2 LDA2021/0139

126-128 Pittwater Road, Gladesville

Alterations and additions to the existing 3-storey mixed use development. 3

City of Ryde
Local Planning Panel Report

Figure 14 – Floor plan of original proposal (enclosed area with hatching has been deleted with the amended proposal and the enclosed area to the west has been reduced by 23m²)

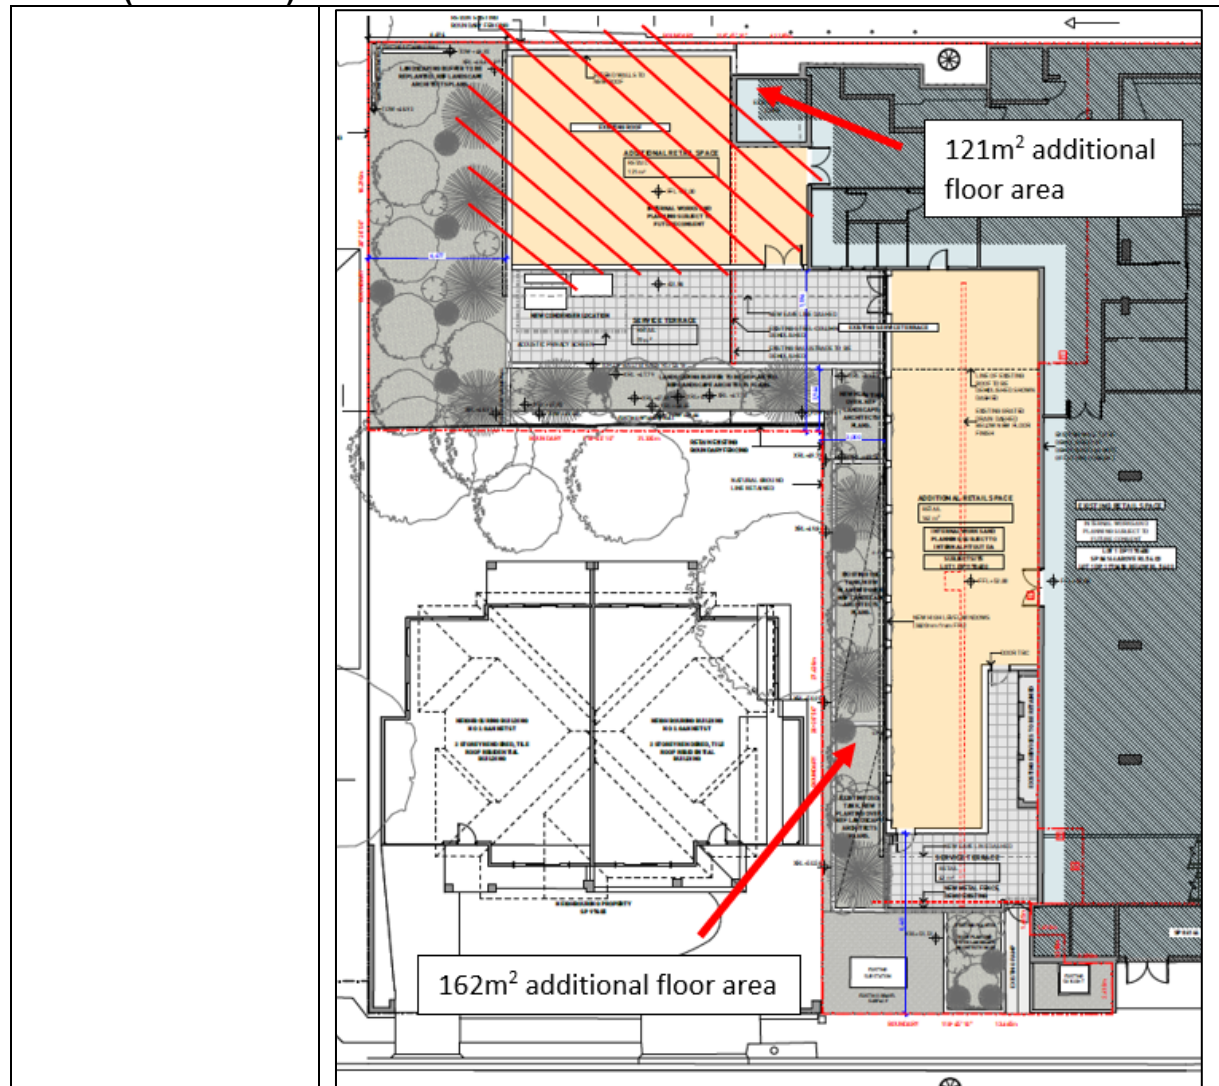
Assessment Officer's Comments: The enclosed extension to the north west has been deleted from the proposal. This issue was addressed by the amended plans.

Figure 19 – Setbacks notated on ground floor plan

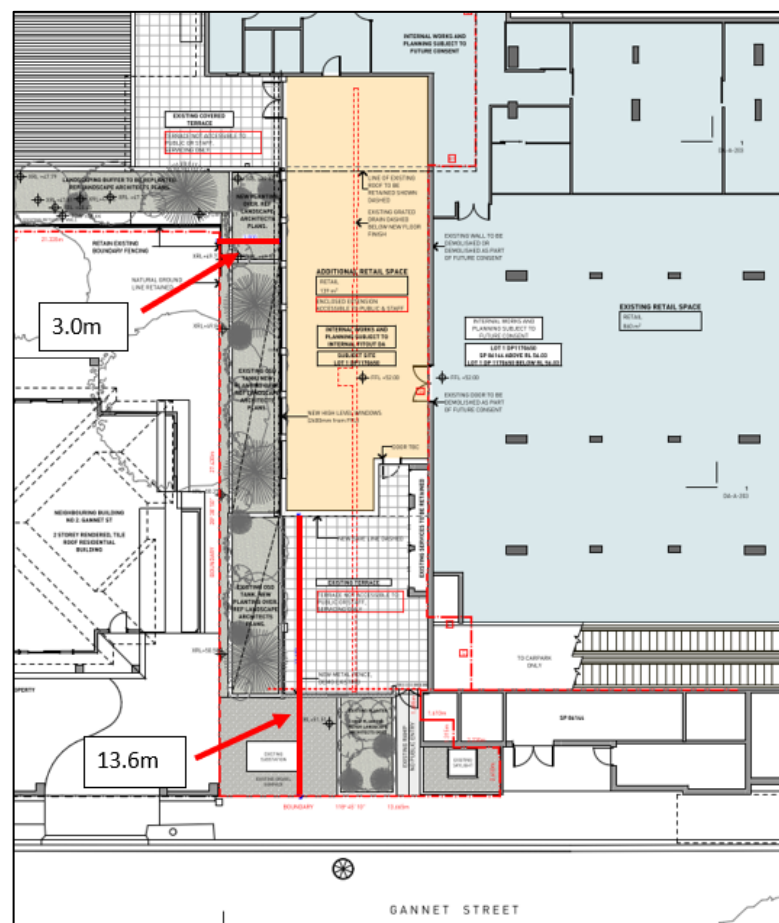
The proposed development will not be visible from the Pittwater Road frontage. The proposed enclosed extension is setback 13.6 metres from the Gannet Street frontage. The separation from the southern boundary prevents the proposed structure being a prominent feature. The setbacks of the existing building are unchanged. The proposed structure maintains a 3 metre setback from the western boundary. It is noted that the RDCP 2014 requires a 1.5m side setback for two storey dwellings/dual occupancy developments. The existing setback to the terrace, which appears as a two storey structure once enclosed, doubles the 1.5m side setback. This allows for adequate separation for landscape screening and amenity for the adjoining residential property.

Figure 21 – Amended landscape plan showing landscape buffer between the subject site at 2A Gannet street is being retained

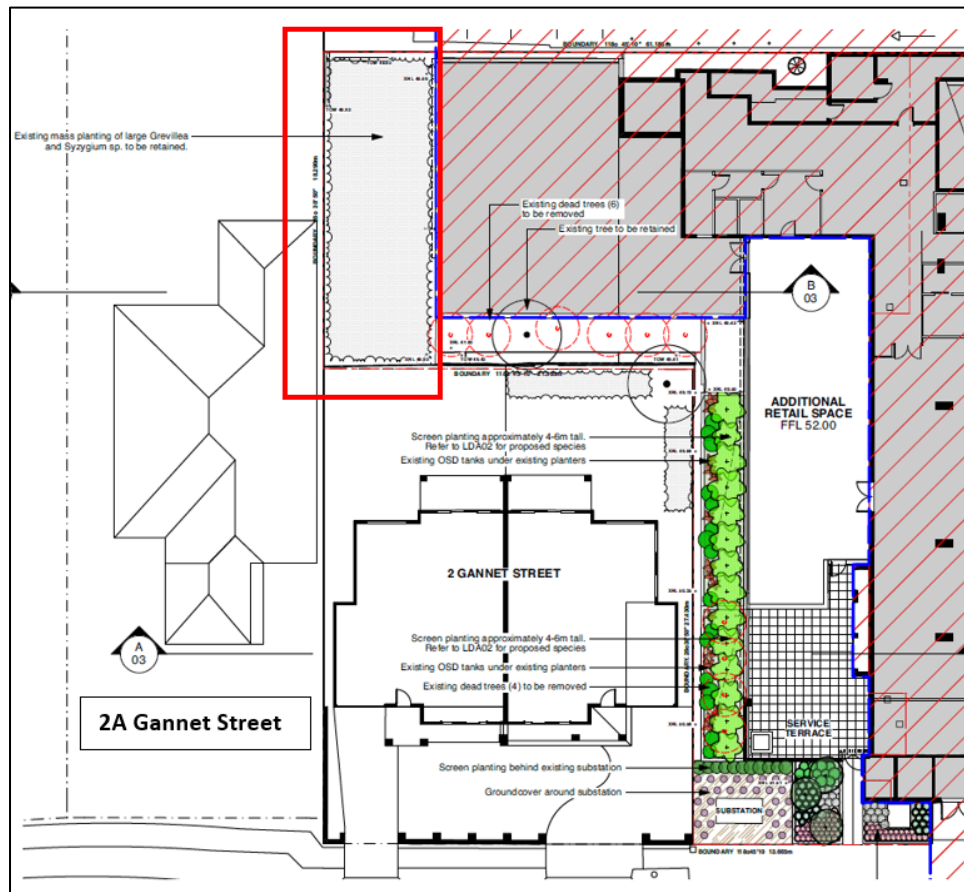
Concern is also raised new planting could also fail, resulting in significant visual and noise impacts.

Assessment Officer's Comments: The amended landscape plan shows no trees are proposed to be removed from the landscape buffer between the subject site and 2A Gannet Street.

The proposal seeks to remove the existing dead trees and provide screen planting along the western boundary. A landscape maintenance program and ongoing maintenance regime is proposed to ensure the maintenance of the proposed landscaping. **Condition 36** is recommended requiring the landscape maintenance program and ongoing maintenance regime identified on the landscape plan Dwg No. LDA-01 Issue 03 dated 23/08/2021 shall be adhered to.

Figure 22 – Amended landscape plan showing screen planting only proposed on the western boundary

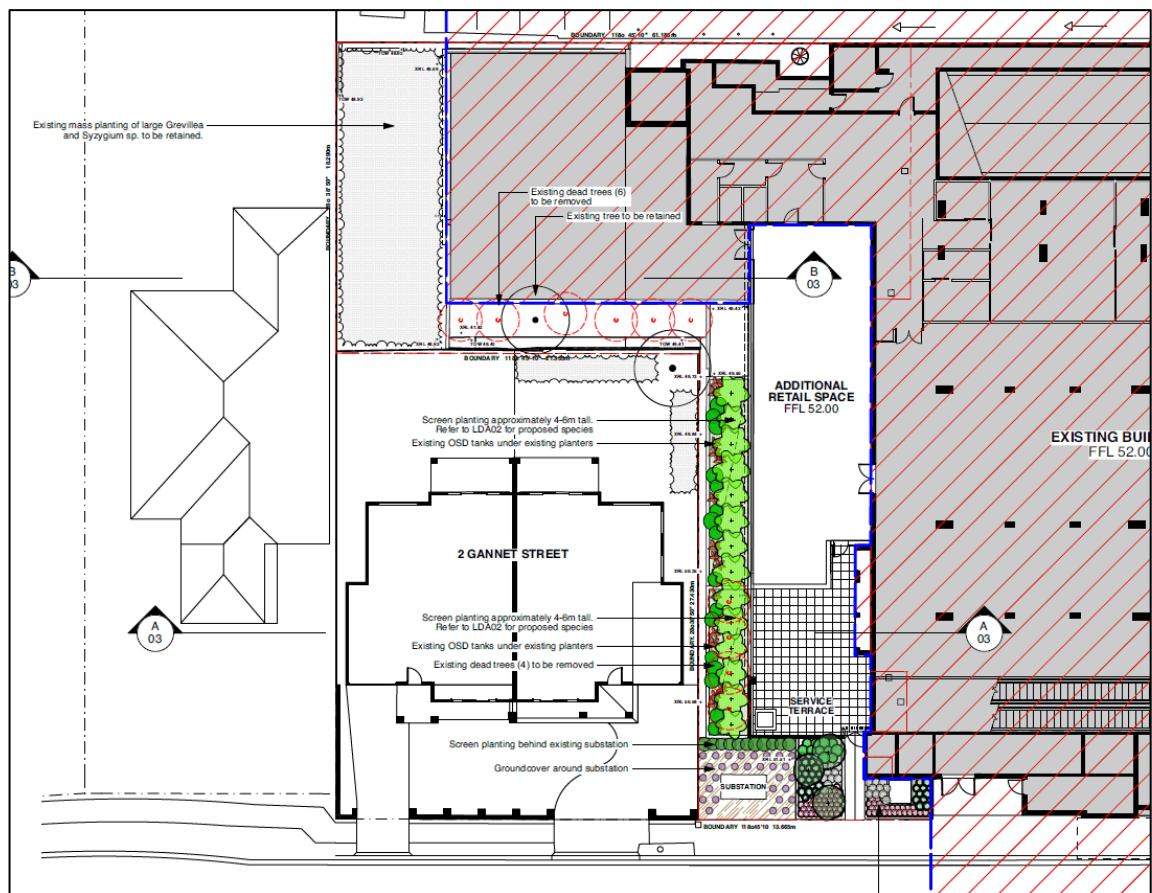
Assessment Officer's Comments: The amended landscape plan shows screen planting is only proposed on the western boundary. The proposed screen planting will not cast shadow on 2 Gannet Street between 12pm to 3pm and is considered acceptable. The proposal is for the extension of an existing neighbourhood supermarket which is a permissible use with the B1 Neighbourhood Centre Zone.

It is noted the amended landscape plan shows screen planting is only proposed on the western boundary. The architectural plans are inconsistent with the landscape plans. **Condition 1(b)** is recommended requiring the landscaping shown on the architectural plans shall be amended to be consistent with the Landscape Plans (Site Plan Project No. 2105 Dwg No. LDA-01 Issue 03, Landscape Plan Project No. 2105 Dwg No. LDA-02 Issue 03 and Sections Elevations Landscape Details Project No. 2105 Dwg No. LDA-03 Issue 03 dated 23/08/2021).

Figure 7: Overshadowing comparison between the proposed retail extension and the existing built form, indicating solar access is retained to the western neighbour (i.e. there is no increased overshadowing generated by the additional/non-compliant FSR)

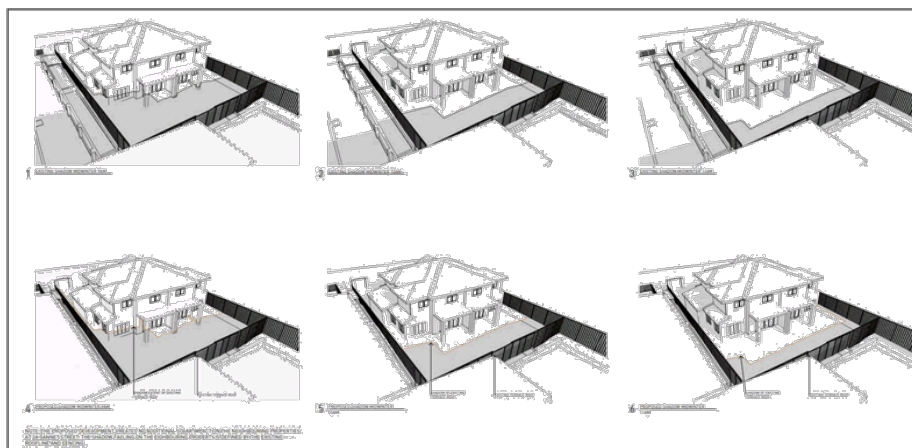
- As indicated in **Figure 7**, the proposed extension/FSR variation will not result in unreasonable overshadowing impacts. The proposal retains appropriate solar access to the adjacent western neighbour's private open space and principal living areas of No. 2 Gannet Street. It is reiterated that the removal of built form to the north-western corner ensures that there is no additional shadow impact associated with the FSR variation.
